City of Atwater

TENTATIVE WASTE DISCHARGE REQUIREMENTS FOR THE CITY OF ATWATER, ATWATER REGIONAL WASTEWATER TREATMENT FACILITY, MERCED COUNTY

**COMMENTS ON THE
TENTATIVE WASTE DISCHARGE REQUIREMENTS
FOR THE CITY OF ATWATER
REGIONAL WASTEWATER TREATMENT FACILITY
MERCED COUNTY
NPDES NO. CA0085308**

ATTACHMENT C – FLOW SCHEMATIC

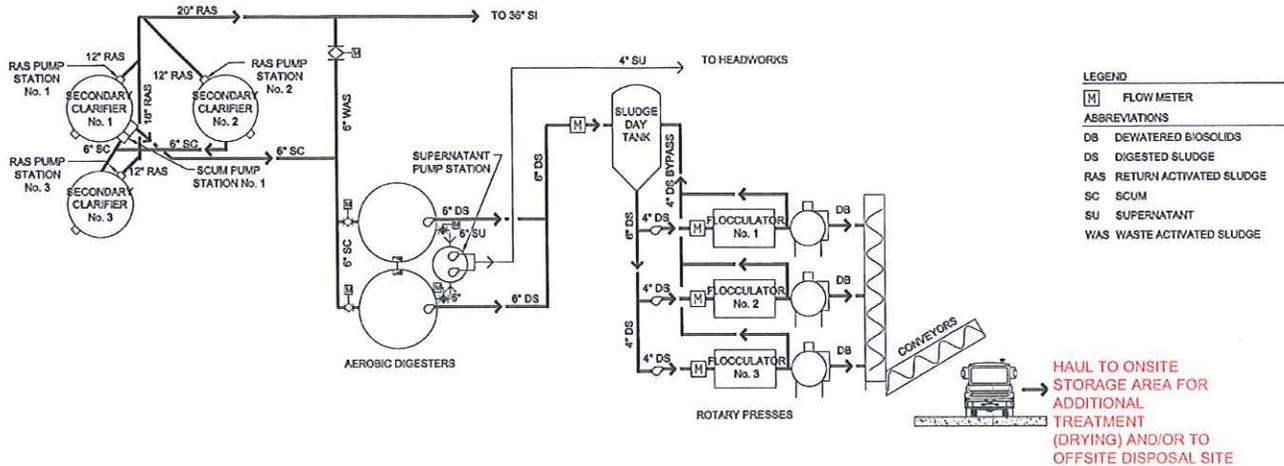
8. As discussed herein, the City proposes to construct a biosolids drying area within the next year. We have attached a revised Flow Schematic that reflects these changes.
